Residential and Tourist Development Subdivision
Lot 156 Creek Street Hastings Point
MP06_0154 – Environmental Assessment Exhibition

A Review

Henry James
Consultant Botanist and GIS Practitioner
Email: henryjames@wetnet.com.au

Figure 1

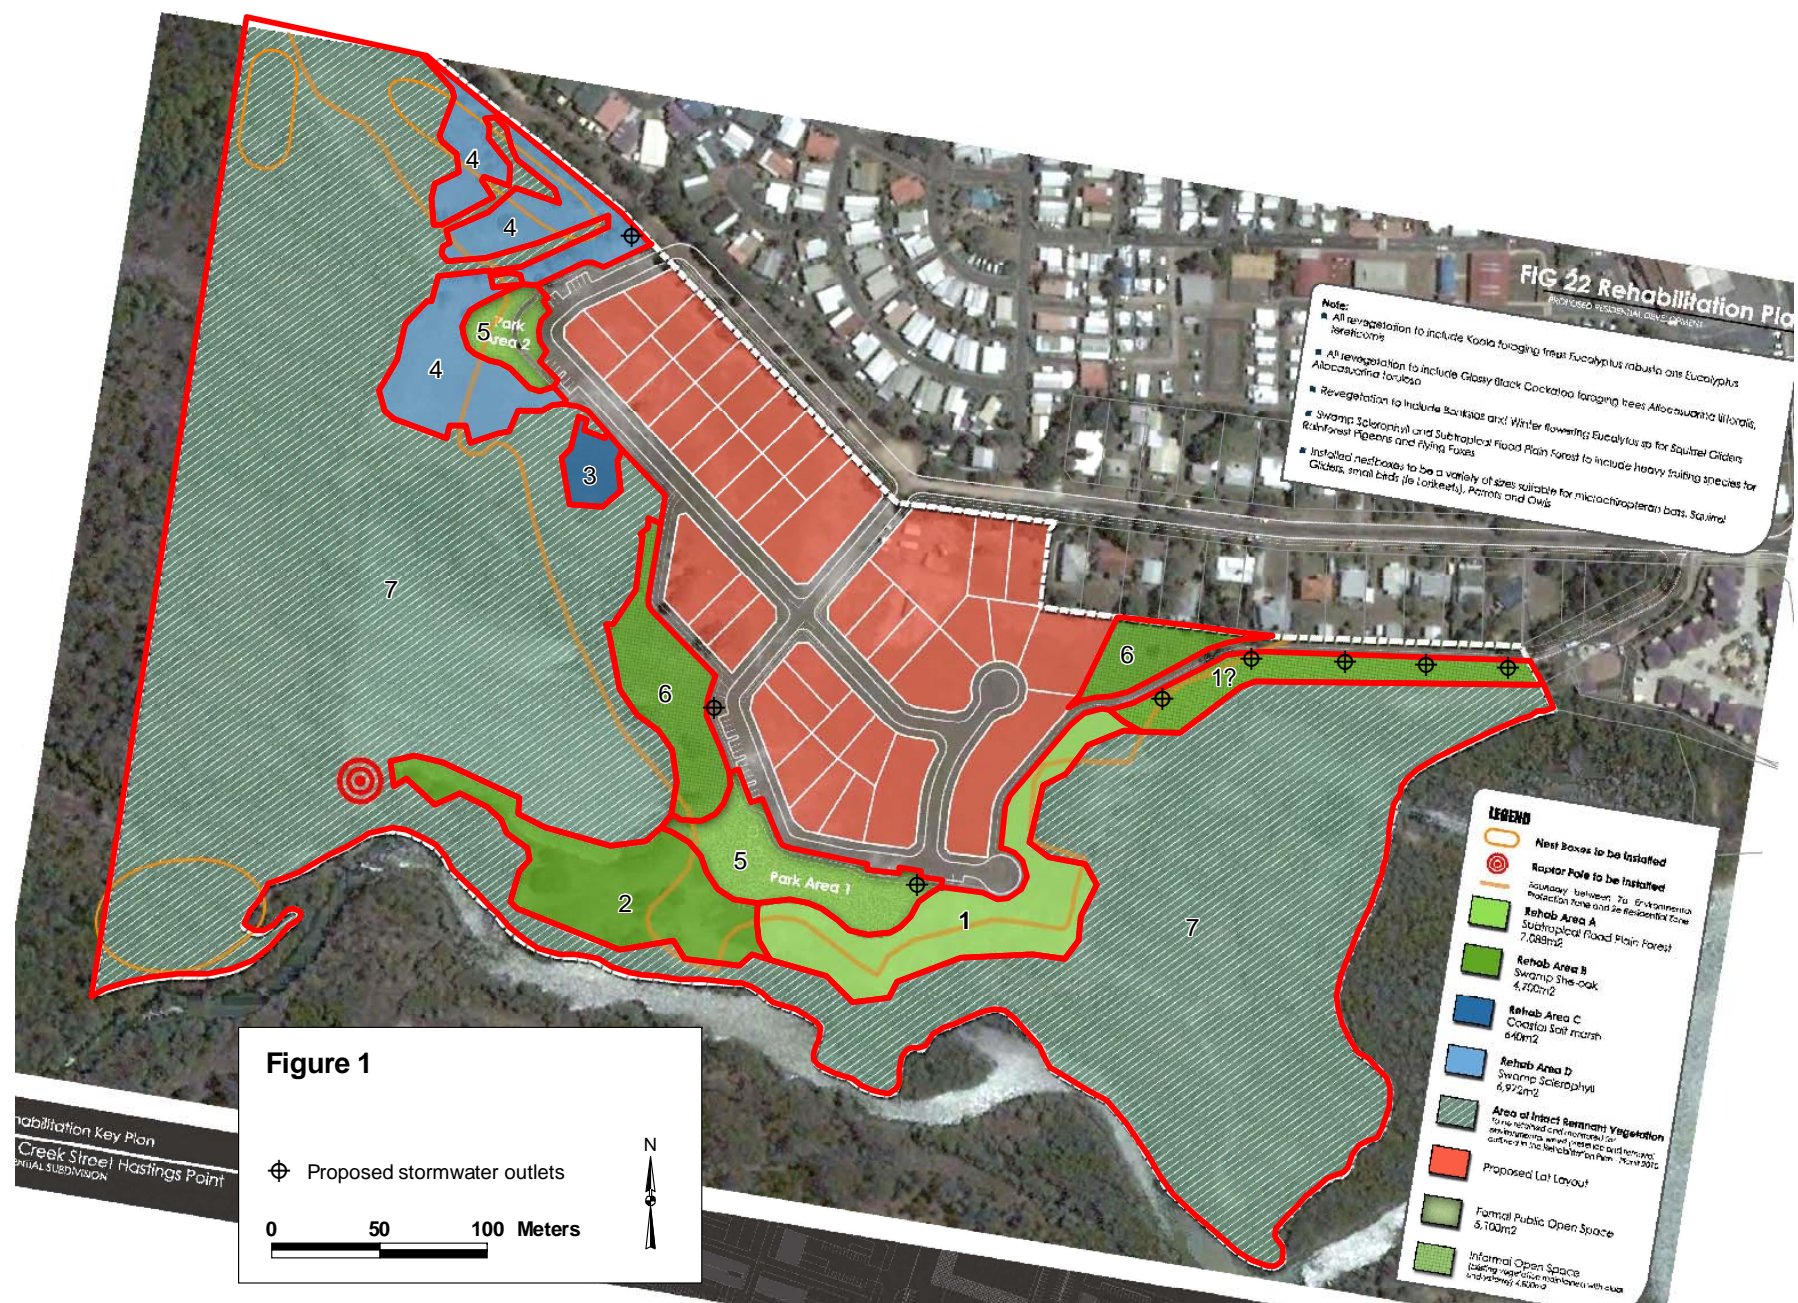
Notably, no GPTs are proposed for catchment C (the area of existing housing along Creek Street). The runoff from this area currently crosses 20 to 50 metres of grassland on the subject site before it reaches the wetlands to the south. The proposal is to eliminate this current infiltration path and pipe the runoff directly to the wetlands at five locations.

All proposed stormwater outlets are near areas of Coastal Saltmarsh (see figure 1 below). (Note, the EA does not identify Coastal Saltmarsh at the location of some of the proposed outlets, but this is yet another failure of the EA. (See a critique of this inadequacy elsewhere in this review.)

- There are internal inconsistencies in the depictions of the types of management for particular areas proposed for dedication.
- There are internal inconsistencies in the claims made for the size of areas of proposed dedication.
- A GIS analysis of the proposed dedications reveals many errors in the claims made with regard to the size of the areas proposed for dedication.

- In Figure 22 – Rehabilitation Plan, an area in the eastern part of the site south of the proposed flood access track is labeled “informal open space (existing vegetation maintained with clear understorey)”. In Figure 14 - Landuse Plan it is labeled “rehabilitated vegetation”, not “informal open space (existing vegetation maintained with clear understorey)”. The area in question is about 2,500 m² in size. See Figure 1 in this submission for a depiction of the location which is labeled “1?”. See also Table 1 below.
- There is a difference of 2992m² between the area claimed in Figure 22 for all types of dedication (apart from “area of intact remnant vegetation”) and area calculated using GIS.
- The figures for dedications in the executive summary do not add up (see Table 2 below). The error is 0.48 ha in size.
